CITY OF ALBUQUERQUE

Re: US Eagle FCU – Juan Tabo
1955 Juan Tabo NE
Traffic Circulation Layout
Engineer's 11-21-19 (H21D029)

The TCL submittal received 03-13-2020 is approved for Building Permit with. A copy of the stamped and signed plan will be needed for each of the building permit plans. Please keep the original to be used for certification of the site for final C.O. for Transportation.

SHEET NUMBER: C-100

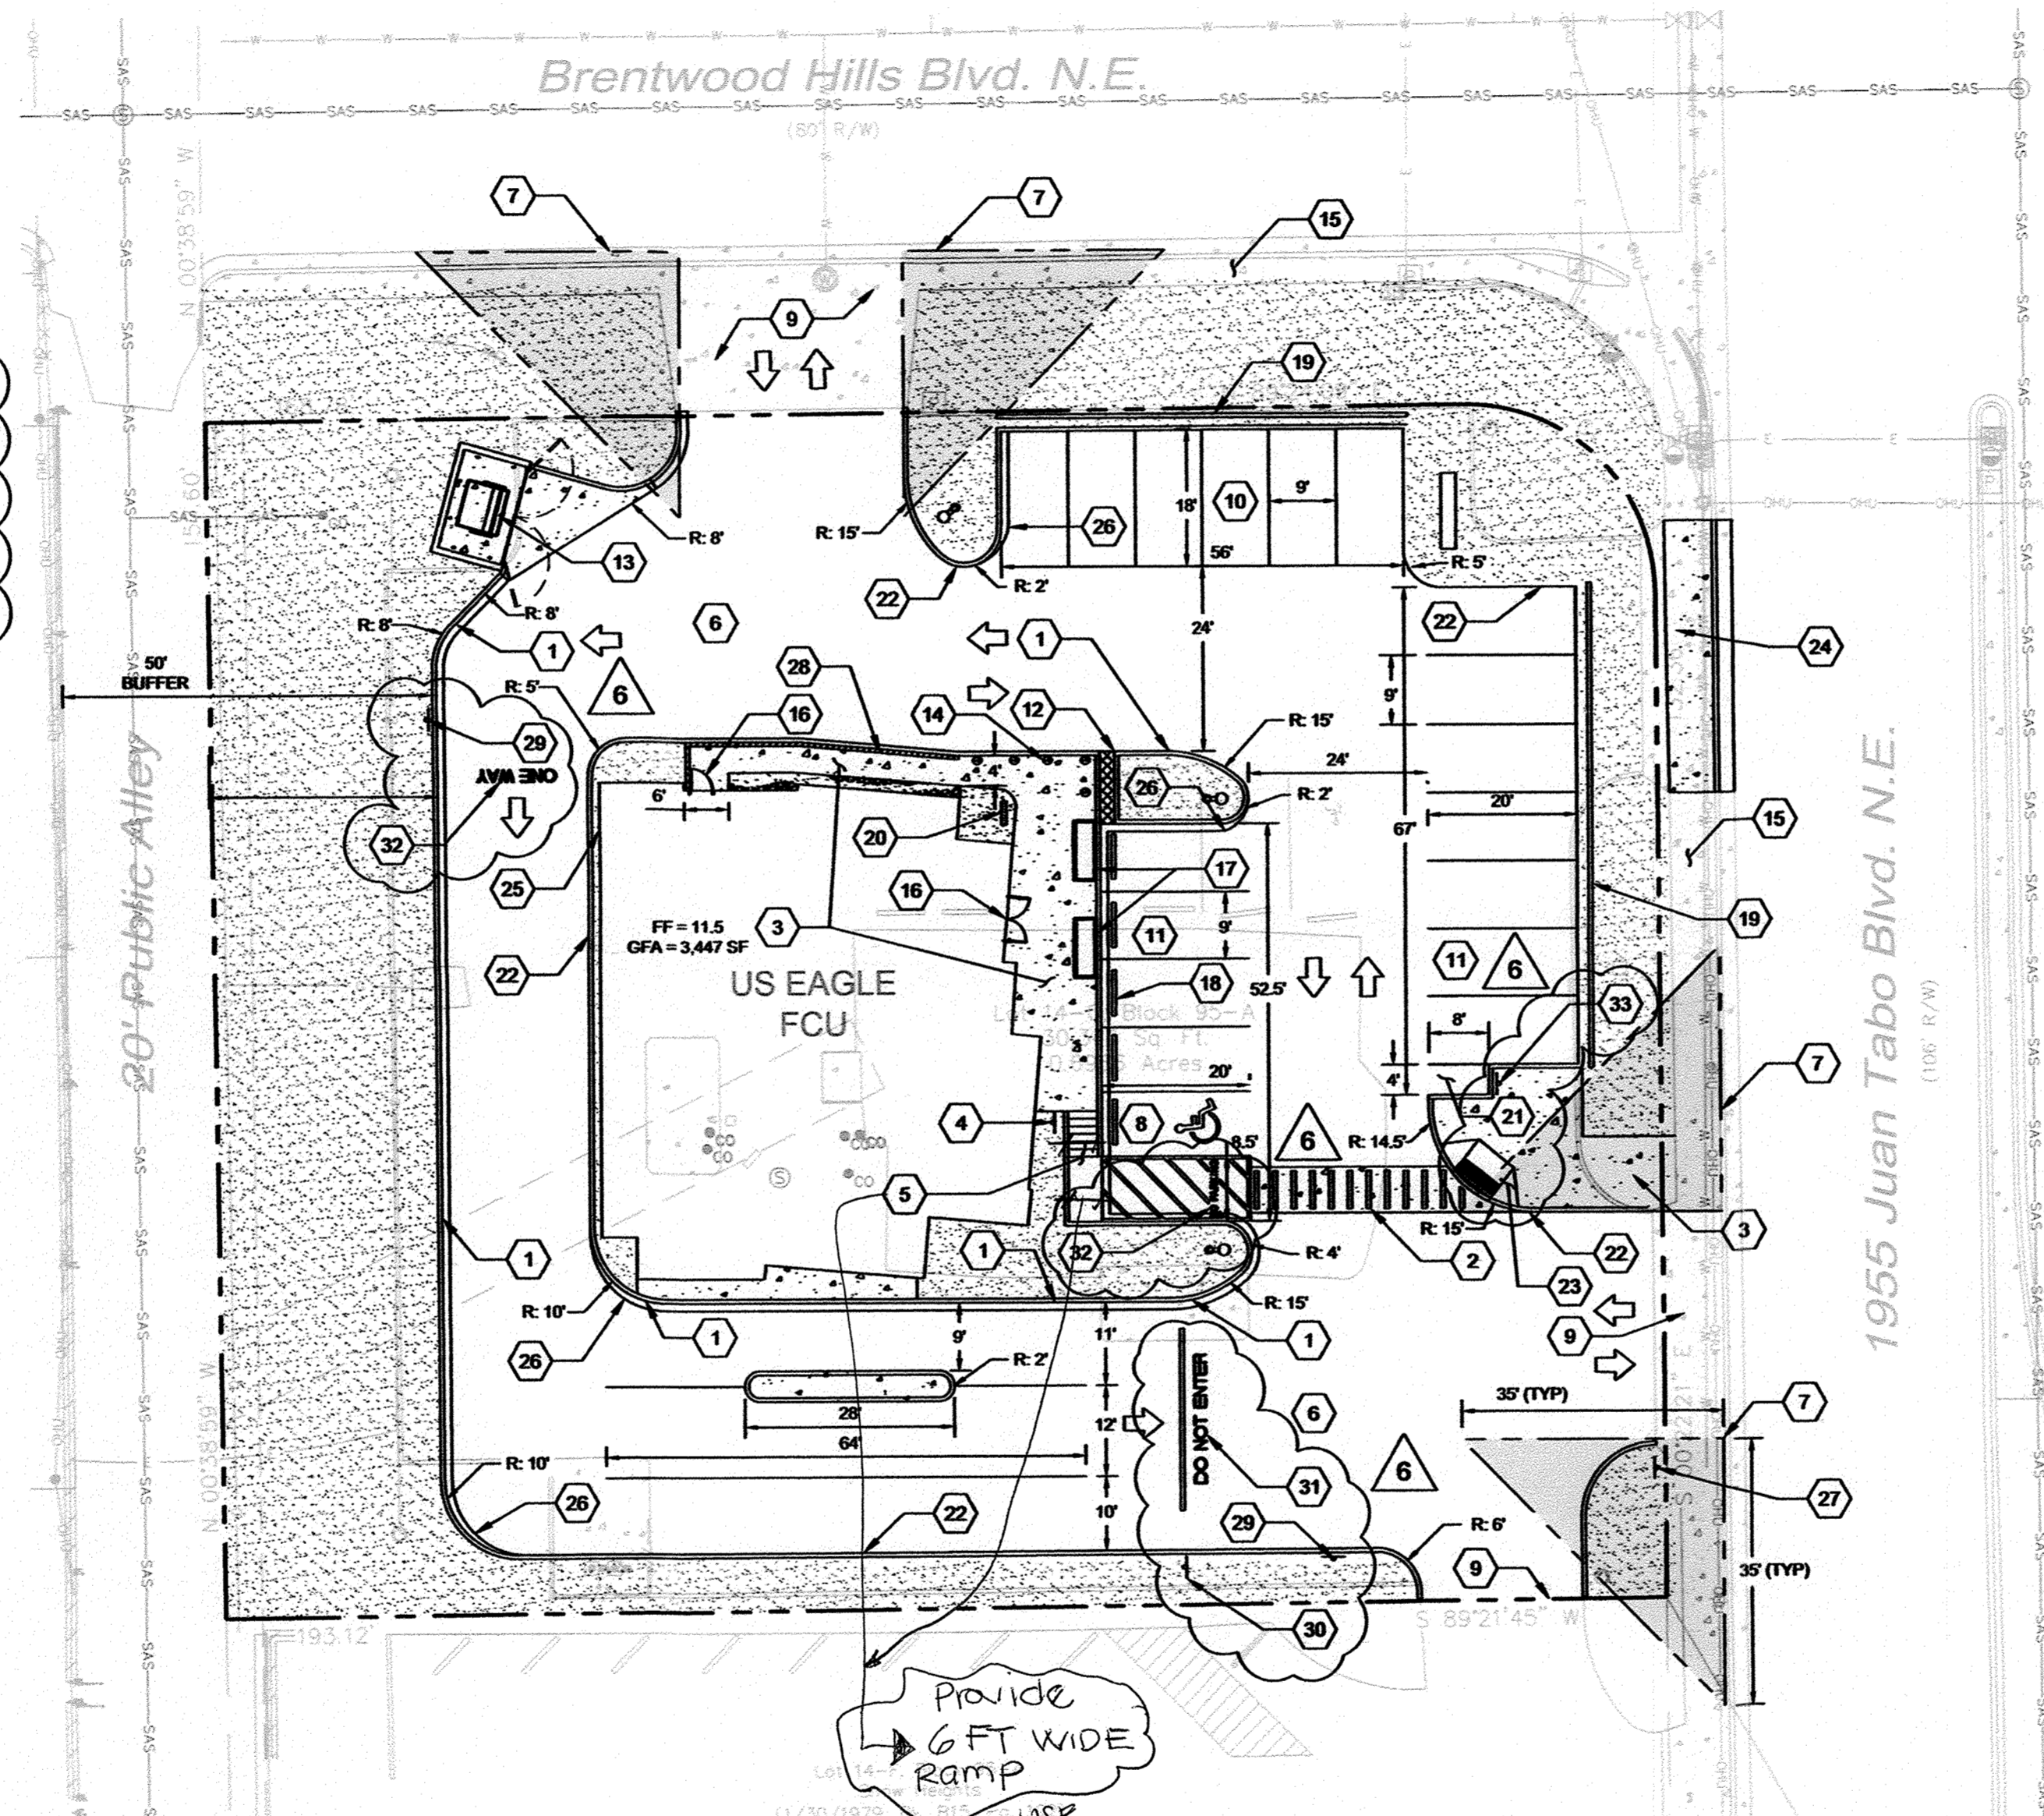
| 5 | PROPOSED ADA RAMP. SEE SHEET C-500, DETAIL 7. (6 FT WIDTH) NSF 3/16/20 |
